Re: Plan Change 27 Additional Information

Proposed Outline Development Plan
South West Rangiora
Townsend Road Residential 2 Zone
for MA Clarke and Willaims McKenzie Trustees Limited

Re: Plan Change 27: Flood Displacement Modelling

DIFFERENCE IN HEIGHT BETWEEN
PRE AND POST DEVELOPMENT MAXIMUM FLOOD LEVELS DURING 200 YEAR RETURN PERIOD
PROPOSED SOUTHBELT SUBDIVISION, RANGIORA

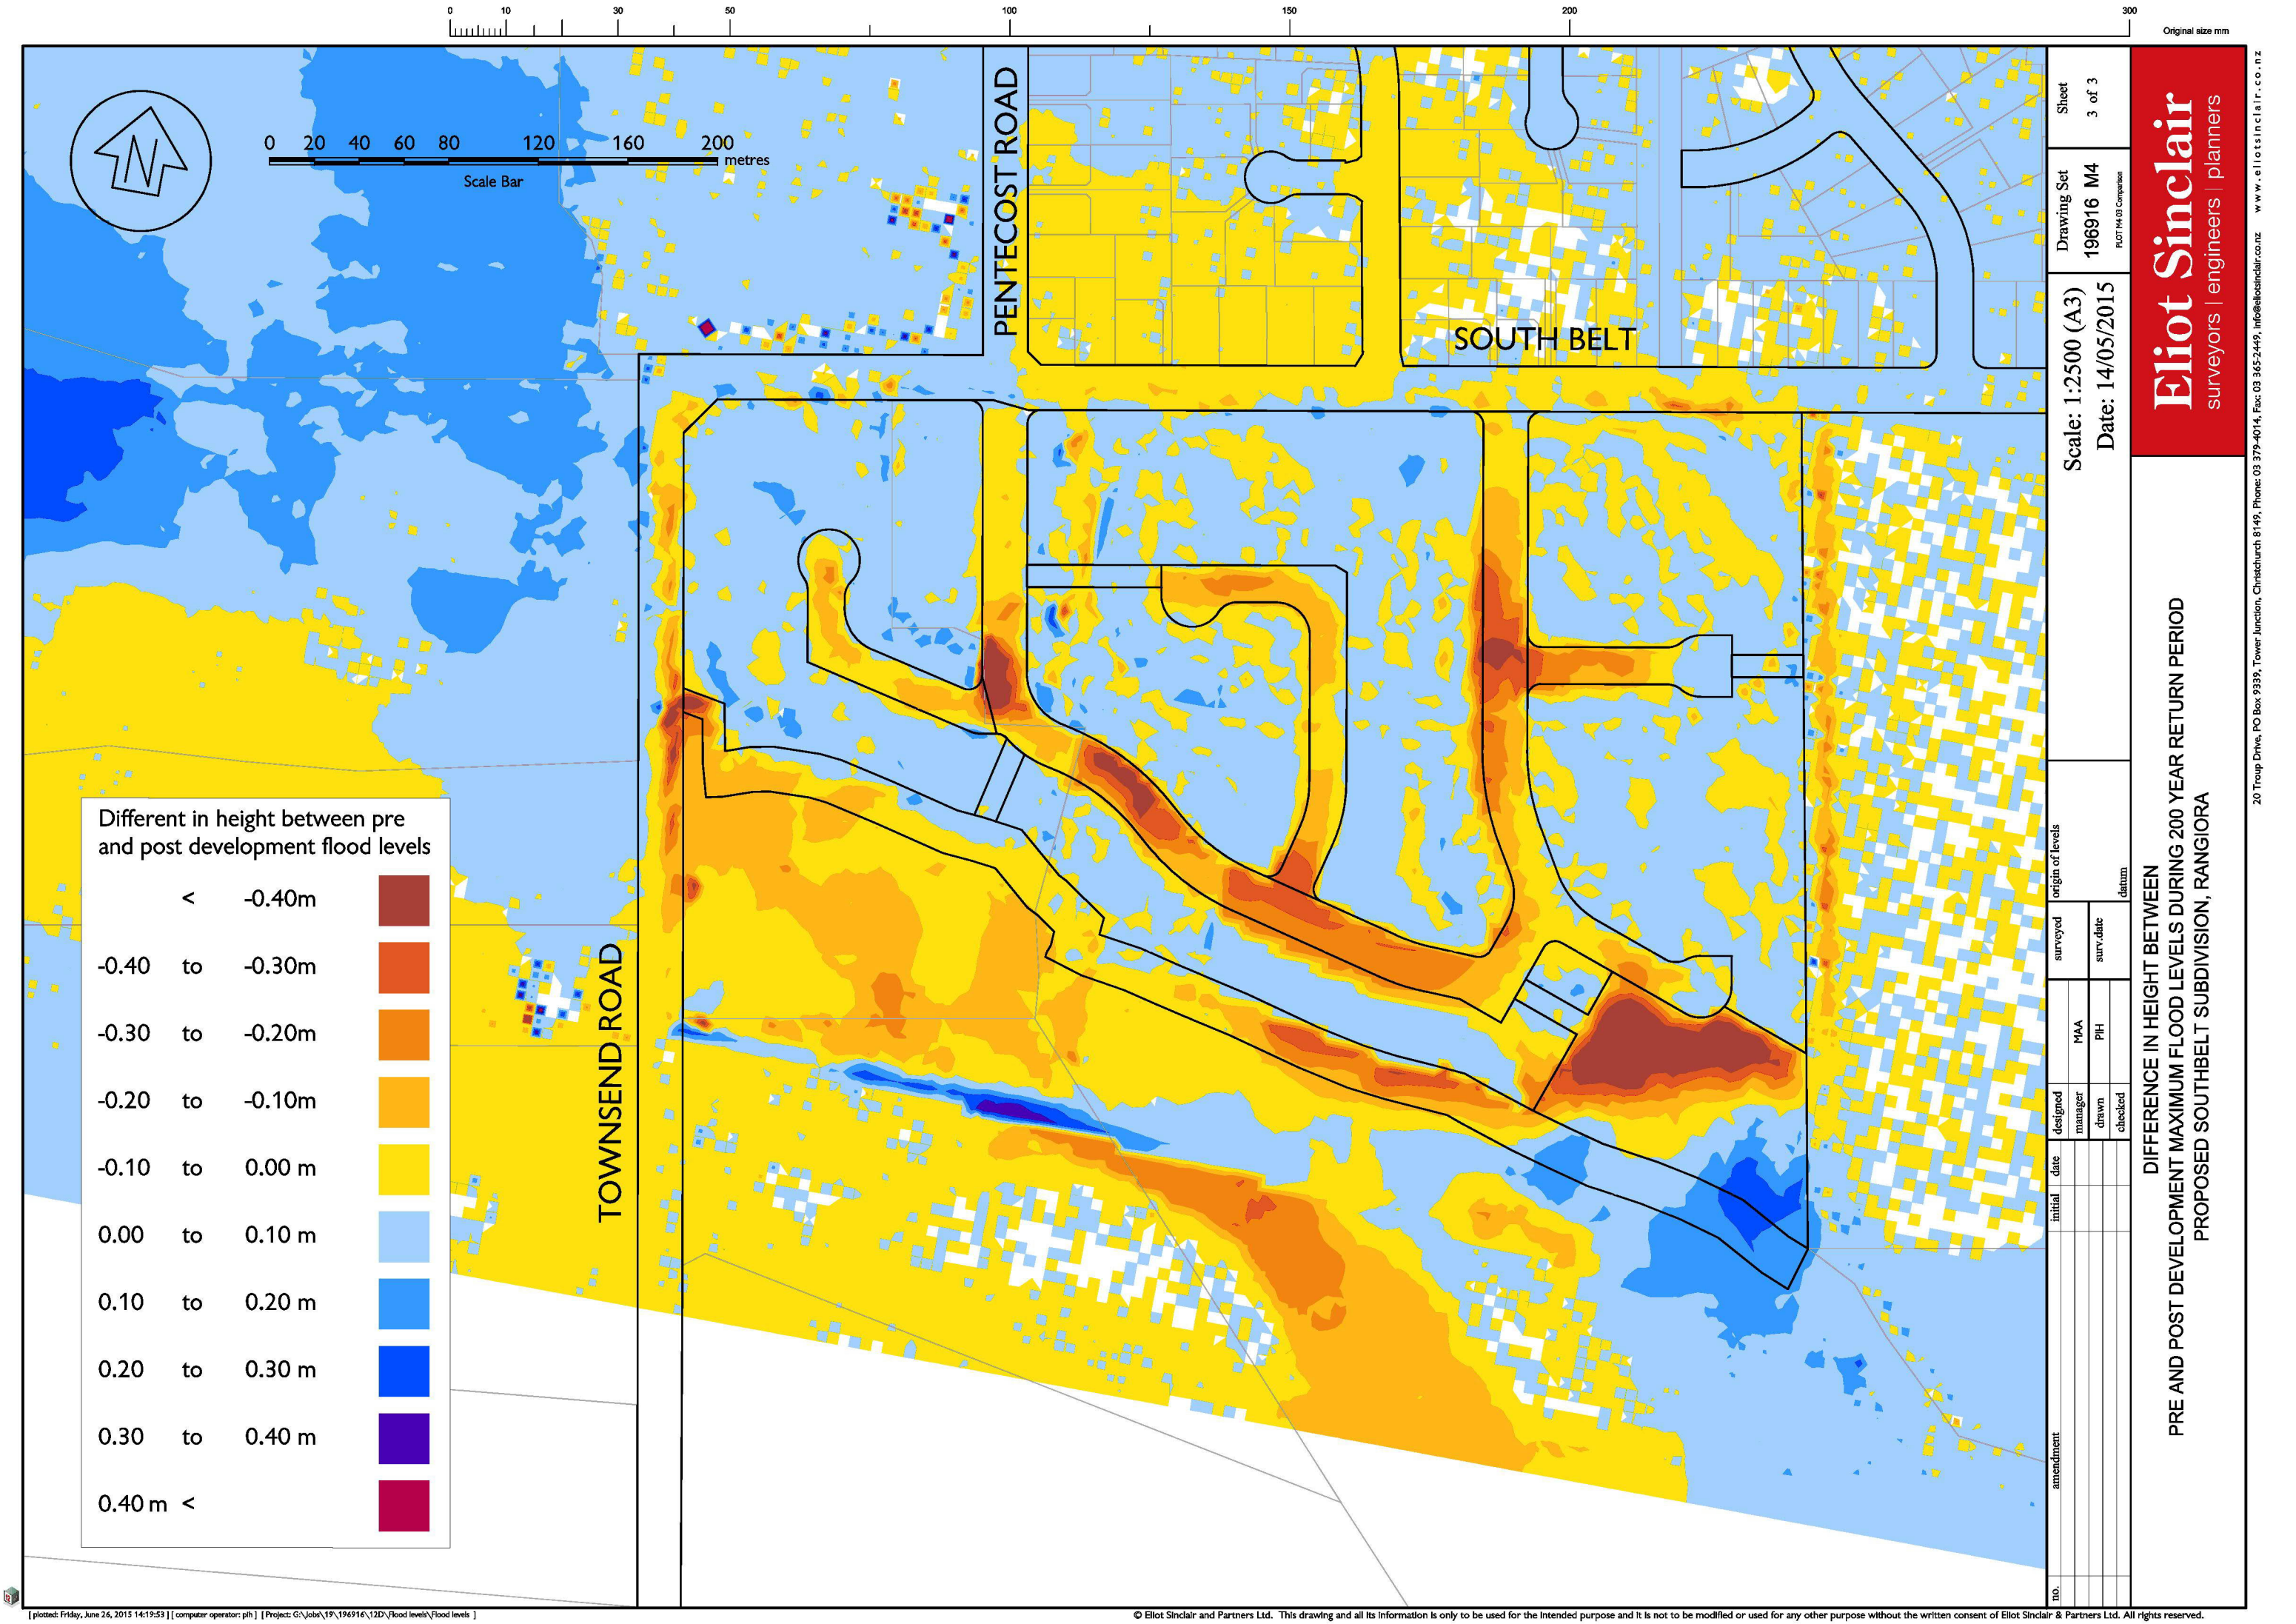
Drawing 196916 M4 Sheet 3 is colour coded to show the difference in the 200 year flood heights between the existing ground level model and the proposed filled site model. The flood modelling indicates that the 200 year flood heights for the proposed filled site will generally be within +/-100mm of the existing heights for the residential parts of the site and the adjoining residential areas north of South Belt. This shows that any change to the 200 year flood risk on the adjoining residential properties is likely to be minimal.

The small areas of darker blue (indicating an increase in flood height of more than 100mm) shown on Sheet 3 within The Site are anomalies resulting from the fill design having been based on the existing 200 year flood heights. These areas represent minor local features and would not appear in the final subdivision design.

The darker blue areas on the adjoining block to the north and west of the intersection of Townsend Road and South Belt shown on Sheet 3 are a result of the modelling methodology. The land is the subject of a separate development proposal and has been modelled with run off coefficients for residential land. However, at this stage no roading or stormwater structures have been included in the model for this land. The inclusion of a subdivision design in the model will be likely to channel the 200 year flood toward the South Brook channel as is the case for The Site, reducing the differences between pre and post development flood heights on this land.
